**STAFF REPORT: 7/14/2021 MEETING**

**APPLICATION NUMBER: #21-7359**

**ADDRESS: 119 GARFIELD STREET**

**SCOPE: REVISION OF PREVIOUSLY APPROVED, MIXED-USE BUILDING DESIGN  
(WORK COMPLETE)**

119 Garfield (detail of current siding and windows), staff photo of current appearance

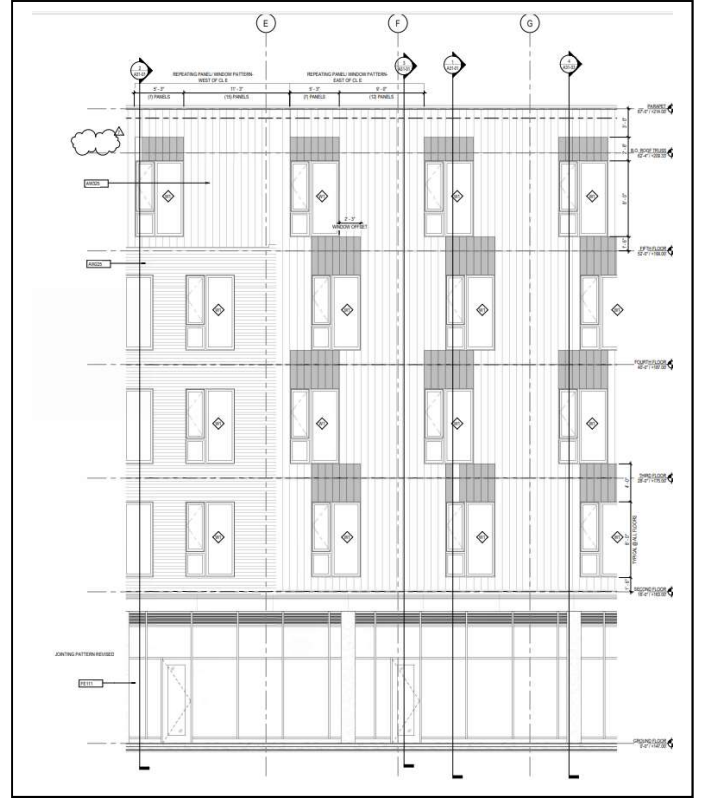
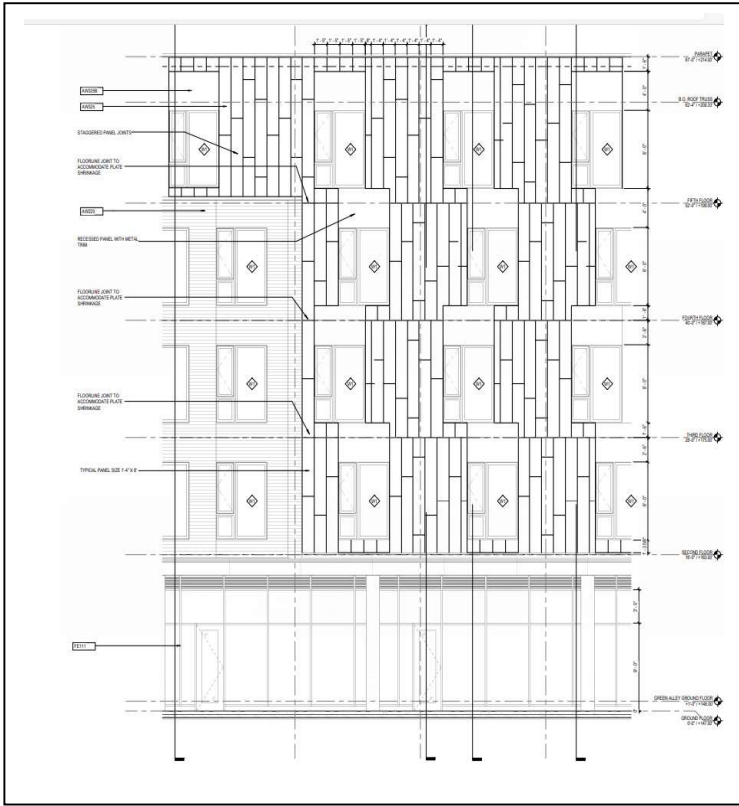
While conducting a recent field visit, staff viewed the property and noted that the current siding was not installed per the Commission's 2019 approval or the approved permit/construction

drawings. Staff therefore reached out to the applicant to discuss the issue and they did confirm that the siding was not installed as per the approved design. Staff further noted that the windows are vinyl, which is also not in keeping with the approved proposal. Finally, the applicant did note that the team needed to revise the approved landscape elements to the west of the building.

① SOUTH ELEVATION- GARFIELD STREET  
1/8" = 1'-0"

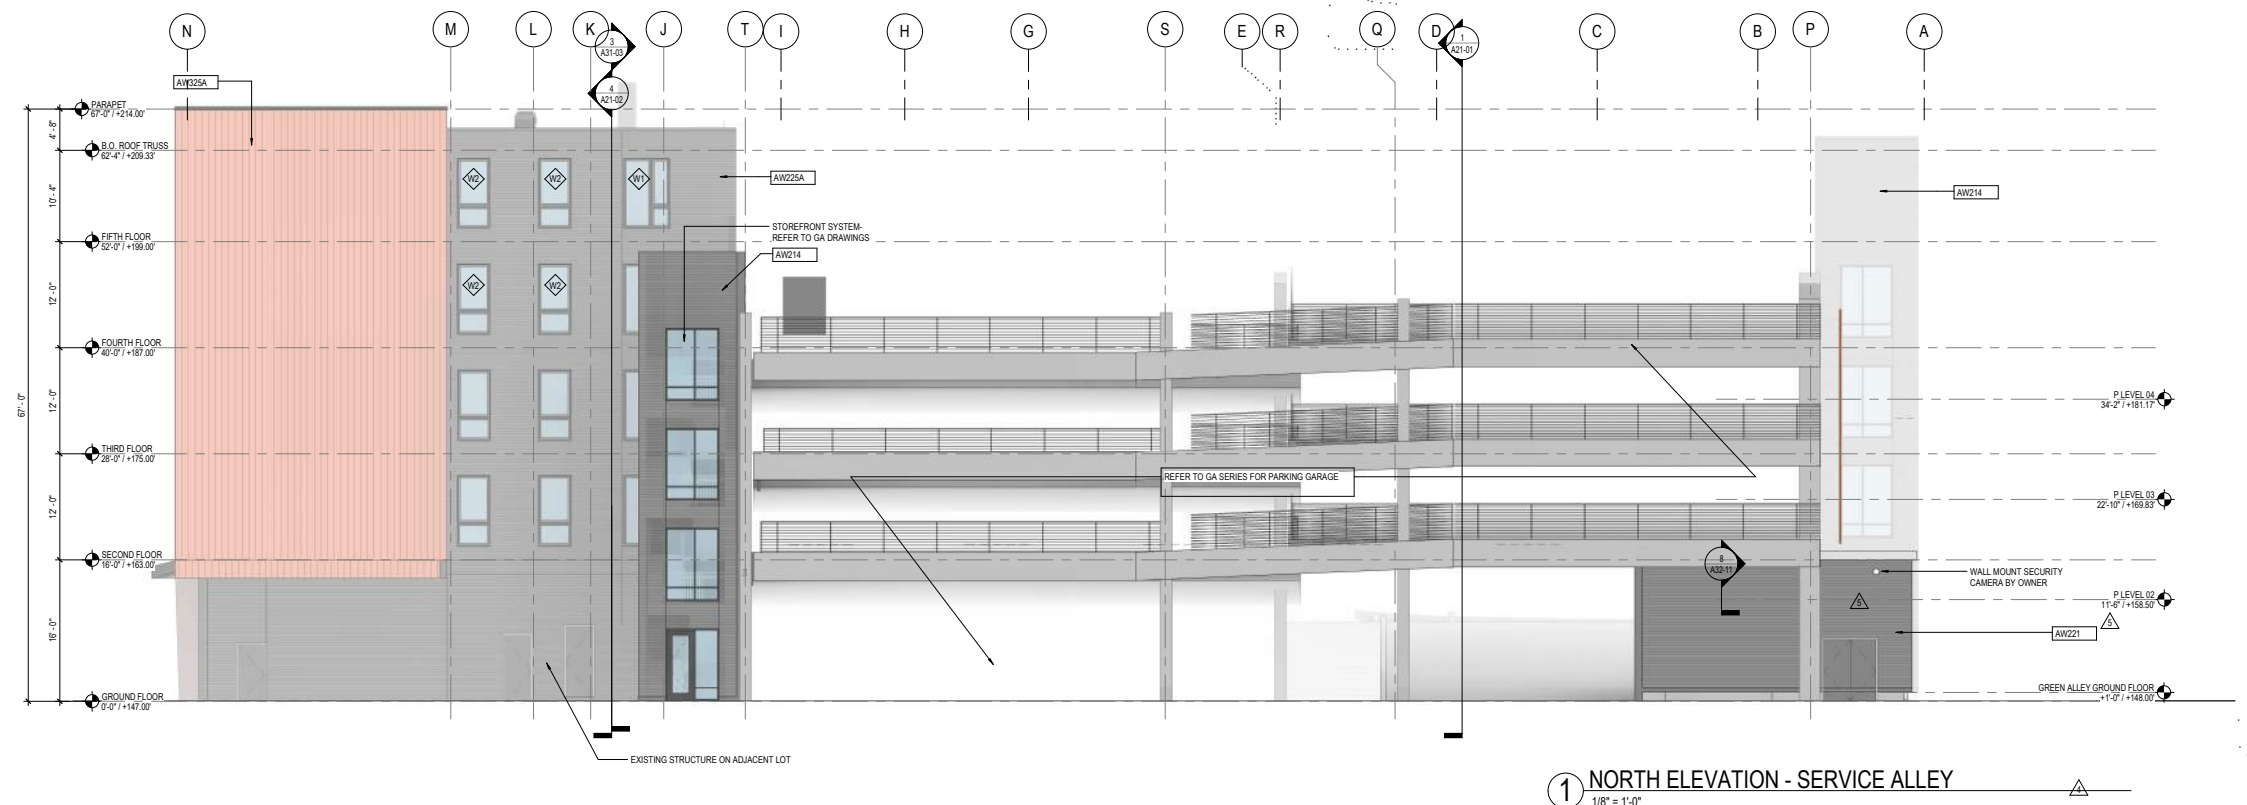
- Loss of wall insulating performance - NGBS Certification
  - Escalating wood prices
  - Hardie would not warranty the detail at "shoulders"
  - Hardie horizontal joint must occur at floor line

- Upgraded to commercial Quaker extruded vinyl windows
  - Higher quality commercial window
  - Steel reinforced frames and sashes
  - Finished, glazed and pre-assembled by Quaker

ELEVATIONS

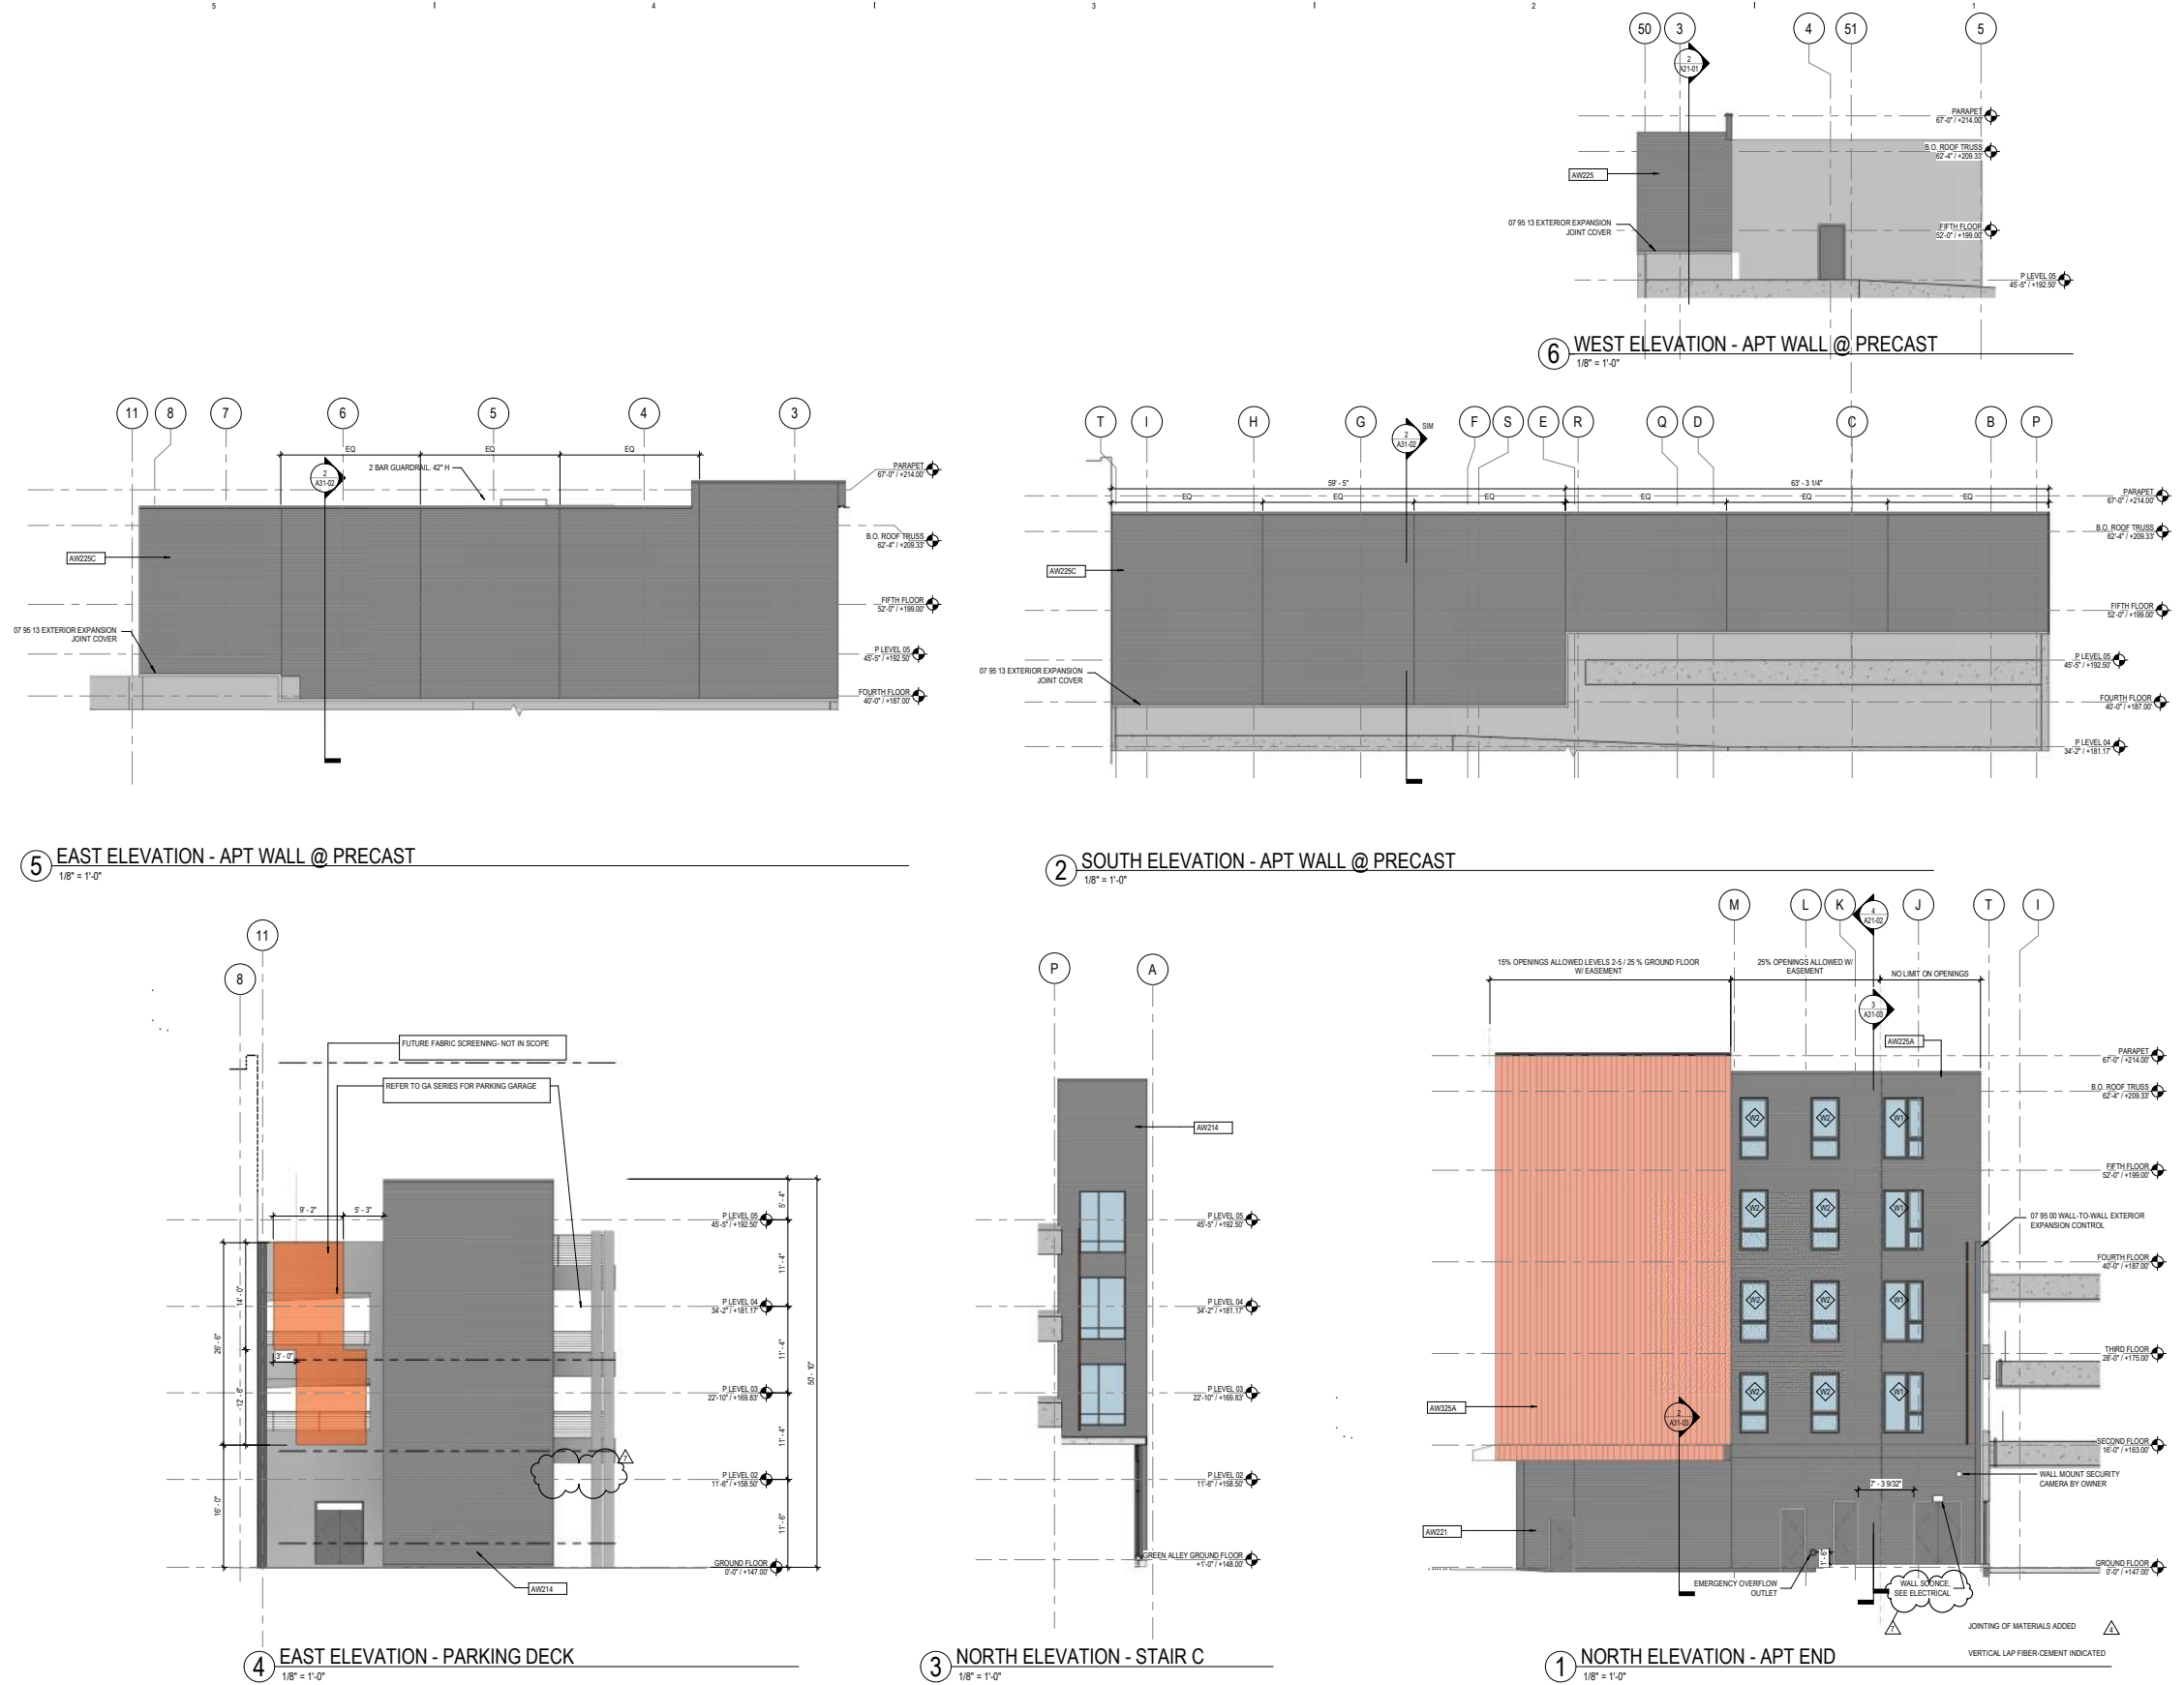
- SIDING SPEC FINALIZED
  - Hardie artisan 5/8" cement board rainscreen siding
  - Uses hardie support furring and trim components
  - Full warranty on siding system, not just the panel boards

- Factory applied finish color - Foxy
- INSET PANEL REMOVED ABOVE WINDOWS
  - Painted hardie siding to match pattern
  - Panelized wood framing delays - in field framing of 2x4

- Loss of wall insulating performance - NGBS Certification
  - Escalating wood prices
  - Hardie would not warranty the detail at "shoulders"
  - Hardie horizontal joint must occur at floor line

7.14.21 - Revised and updated elevation illustrating the built condition

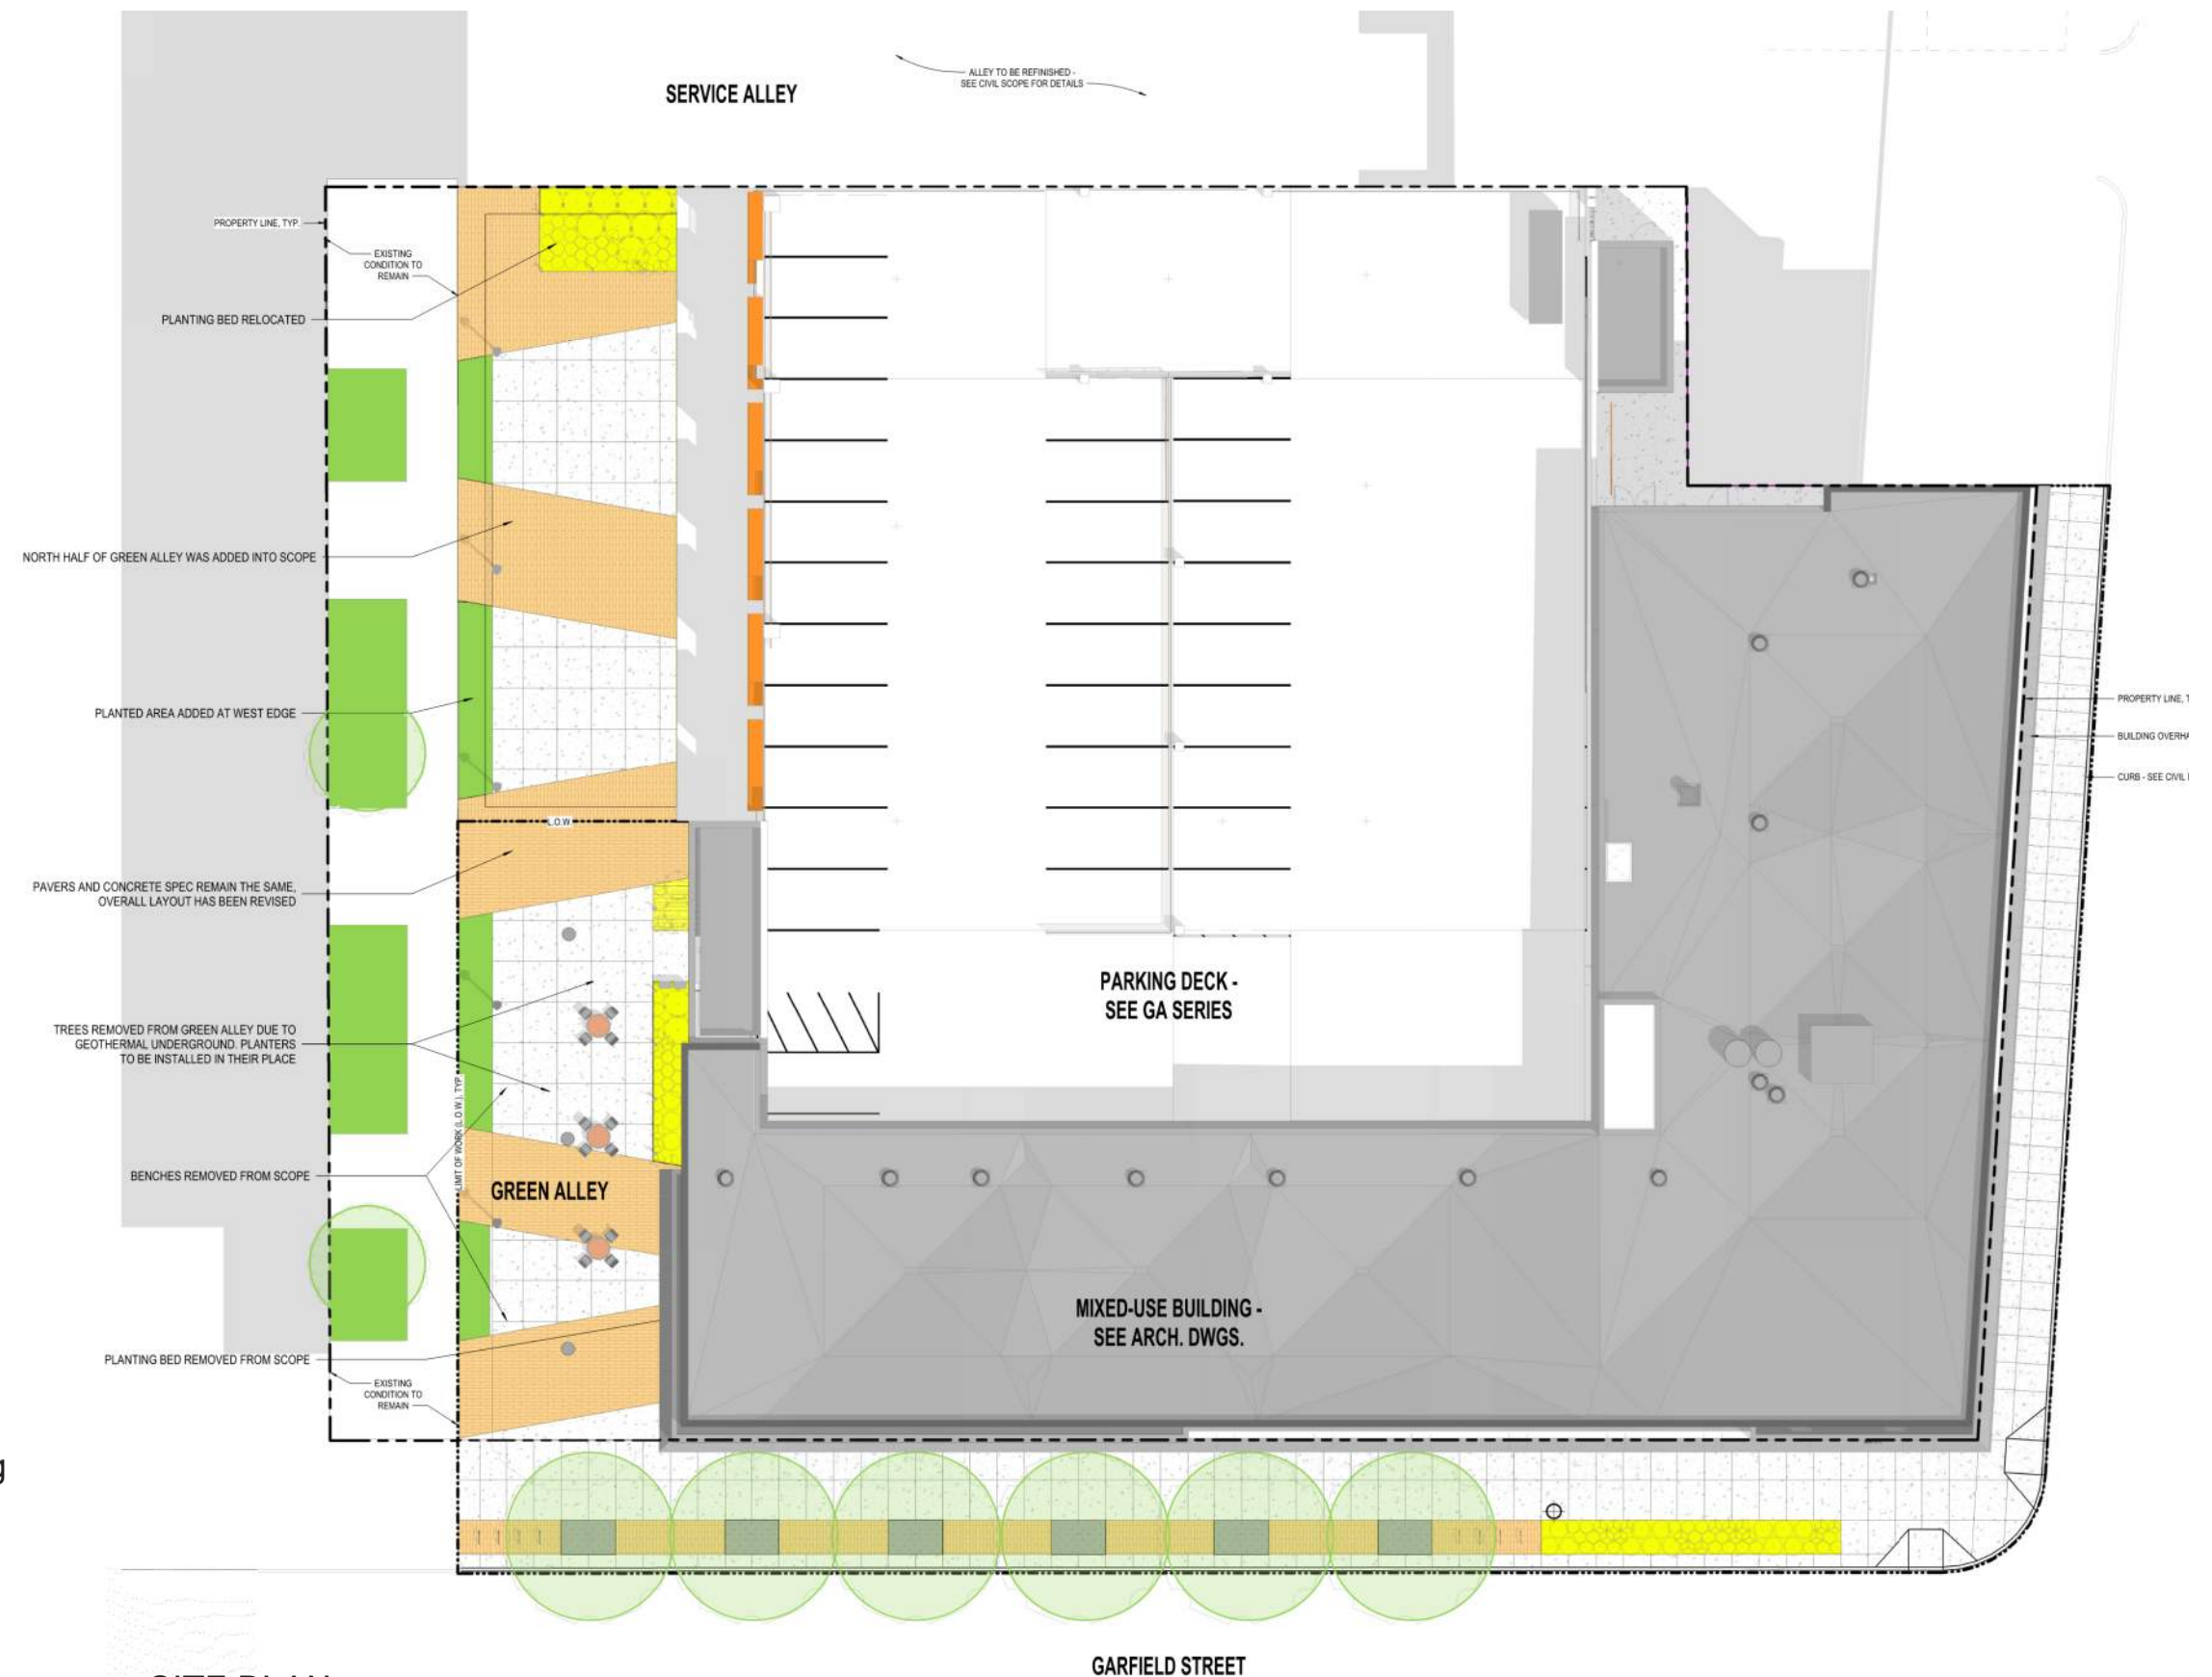
- **SIDING SPEC FINALIZED**
  - Hardie artisan 5/8" cement board rainscreen siding
  - Uses hardie support furring and trim components
  - Full warranty on siding system, not just the panel boards

- Factory applied finish color - Foxy
- **INSET PANEL REMOVED ABOVE WINDOWS**
  - Painted hardie siding to match pattern
  - Panelized wood framing delays - in field framing of 2x4

- Loss of wall insulating performance - NGBS Certification
  - Escalating wood prices
  - Hardie would not warranty the detail at "shoulders"
  - Hardie horizontal joint must occur at floor line
